SUBJECT: ISSUANCE OF AMENDMENT NO. 84 TO FACILITY OPERATING LICENSE
NO. NPF-21 - WPPSS NUCLEAR PROJECT NO. 2 (TAC NO. 76071)

SUBJECT: ISSUANCE OF AMENDMENT NO. 84 TO FACILITY OPERATING LICENSE
NO. NPF-21 - WPPSS NUCLEAR PROJECT NO. 2 (TAC NO. 76071)

AMENDMENT TO FACILITY OPERATING LICENSE

Amendment No. 84
License No. NPF-21

Figure 3.2.1-7

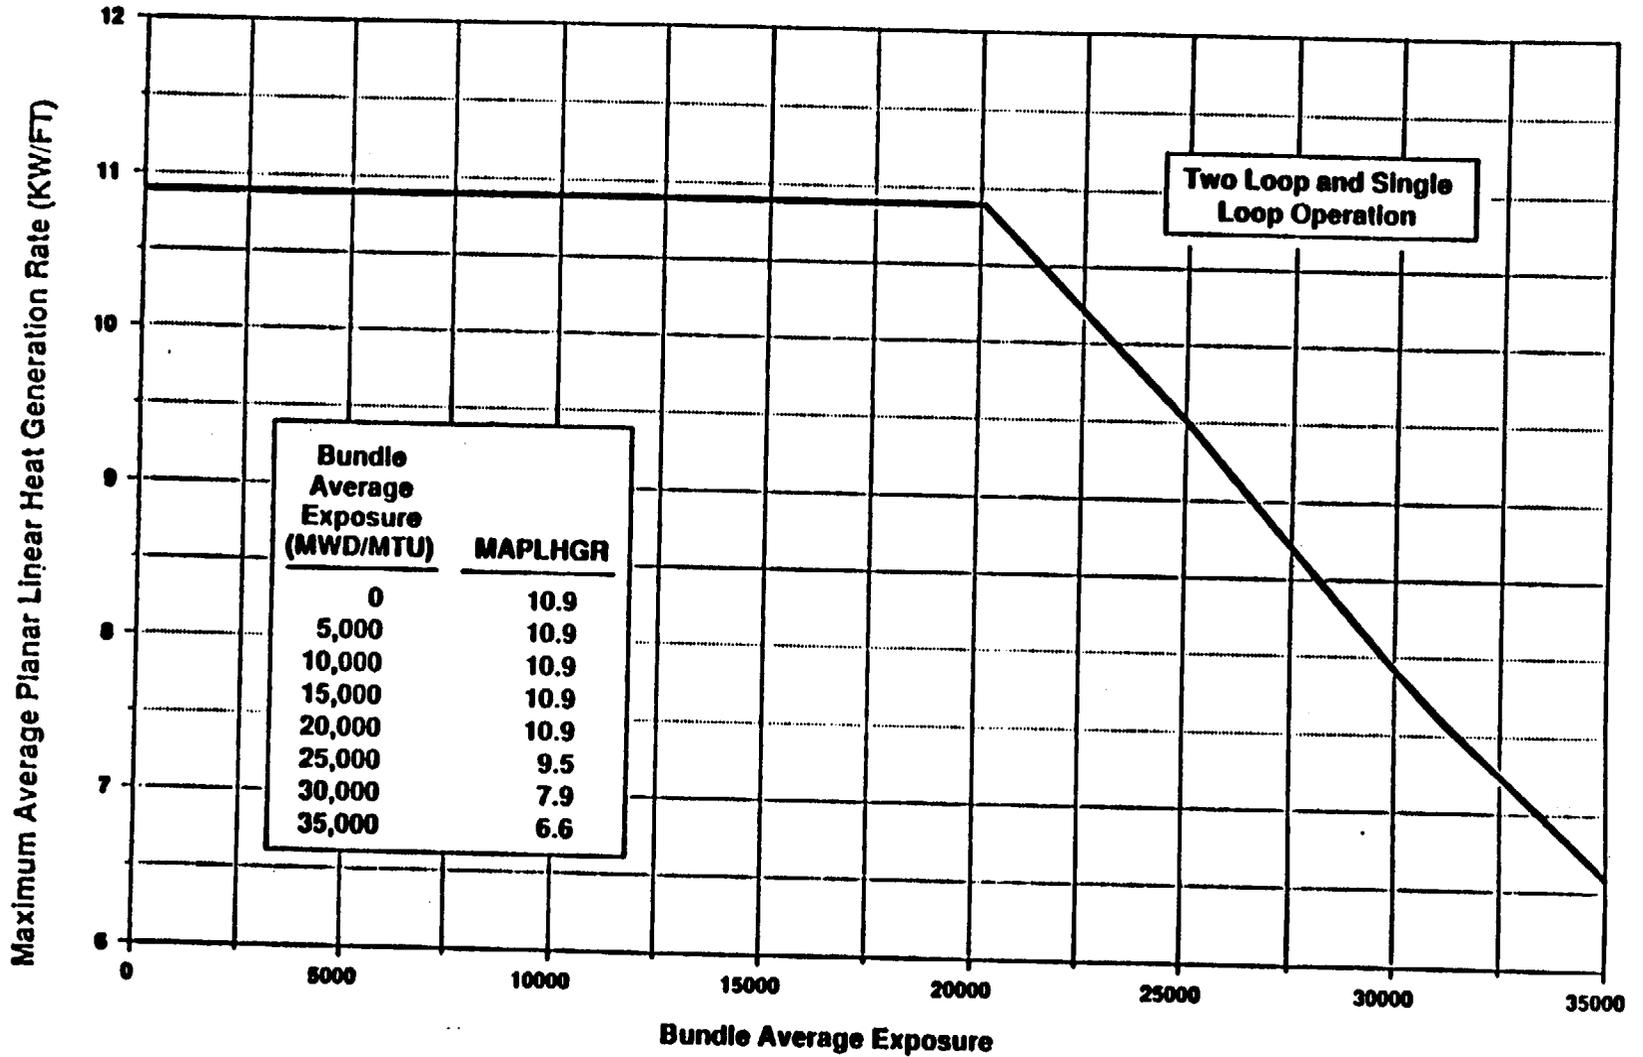
3.2.1 All AVERAGE PLANAR LINEAR HEAT GENERATION RATES (APLHGRs) for each type of fuel as a function of AVERAGE PLANAR EXPOSURE for GE initial core fuel and average bundle exposure for ANF, SVEA-96 and GE11 LFA fuel shall not exceed the limits shown in Figures 3.2.1-1, 3.2.1-2, 3.2.1-3, 3.2.1-6, 3.2.1-7 and 3.2.1-8 when in two loop operation, and Figures 3.2.1-3, 3.2.1-4, 3.2.1-5, 3.2.1-6, 3.2.1-7 and 3.2.1-8 when in single loop operation.

With an APLHGR exceeding the limits of Figure 3.2.1-1, 3.2.1-2, 3.2.1-3, 3.2.1-6, 3.2.1-7 or 3.2.1-8 in two loop operation or Figure 3.2.1-3, 3.2.1-4, 3.2.1-5, 3.2.1-6, 3.2.1-7 or 3.2.1-8 in single loop operation, initiate corrective action within 15 minutes and restore APLHGR to within the required limits within 2 hours or reduce THERMAL POWER to less than 25% of RATED THERMAL POWER within the next 4 hours.

Reduced Flow MCPR Operating Limit
 This Curve is Applicable to ANF Reload Fuel, GE Initial Core Fuel,
 ANF 9 X 9 LFA Fuel, GE 11 LFA Fuel, and SVEA-96 LFA Fuel
 This curve is also applicable to FFTR operation
 Figure 3.2.3-1

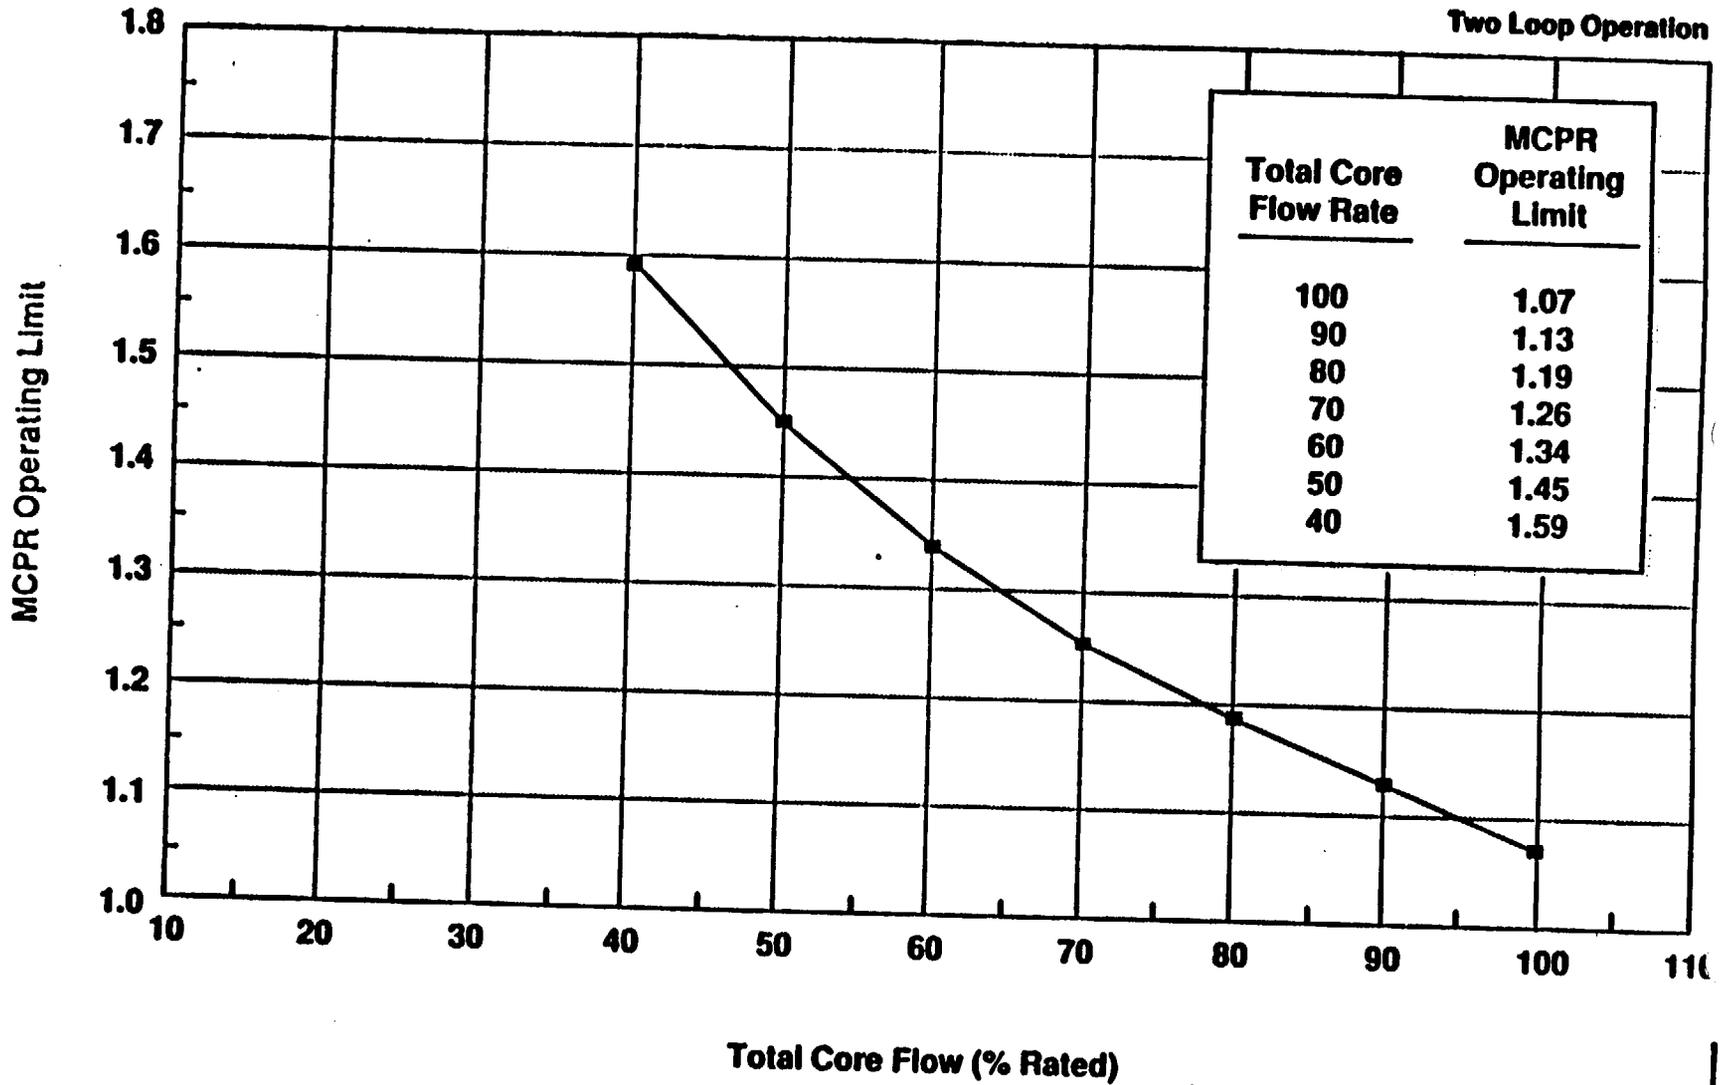
The purpose of the $MCPR_f$ of Figure 3.2.3-1 is to define operating limits at other than rated core flow conditions. At less than 100% of rated flow the required MCPR is the maximum of the rated flow MCPR determined from Table 3.2.3-1 and the reduced flow MCPR determined from Figure 3.2.3-1, $MCPR_f$ assures that the Safety Limit MCPR will not be violated. $MCPR_f$ is only calculated for the manual flow control mode. Automatic flow control operation is not permitted.

This specification and basis are being changed to incorporate MCPR values for the ANF 8x8C and the SVEA-96 LFAs that reflect the Cycle 6 transient analyses including the FFWR option. The GE 8x8 reload fuel, the ANF LFAs, and the GE11 LFAs will be monitored to the ANF 8x8C MCPR limits. In addition, the title of Figure 3.2.3-1 (MCPR Operating Limit versus Total Core Flow) is changed. These changes are acceptable.

Figure 3.2.4-4

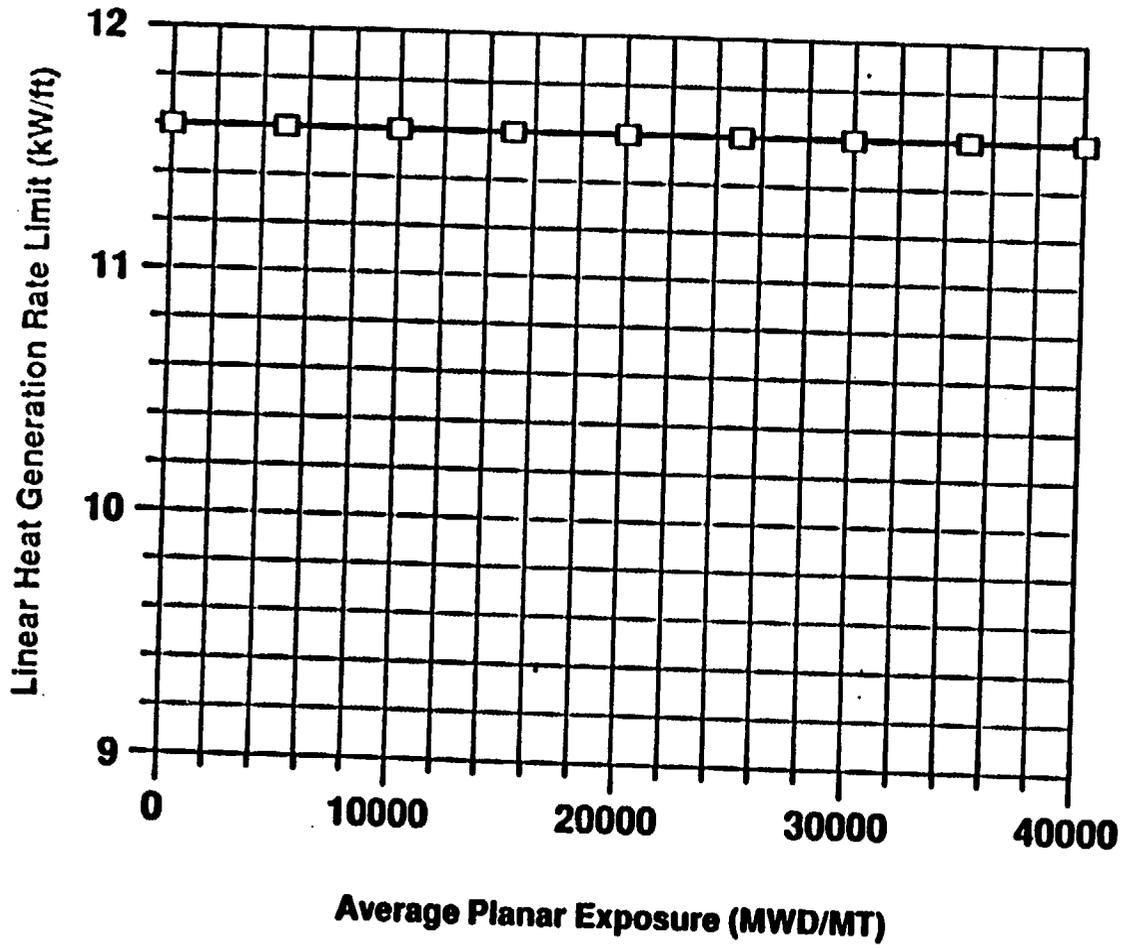
3.2.4 The LINEAR HEAT GENERATION RATE (LHGR) for GE initial core fuel shall not exceed 13.4 kW/ft. The LHGR for reload fuel shall not exceed the values shown in Figures 3.2.4-1, 3.2.4-2, 3.2.4-3, 3.2.4-4 and 3.2.4-5.

This specification is changed to include the LHGR limits for the GE11 LFAs and SVEA-96 LFAs. This change is acceptable.
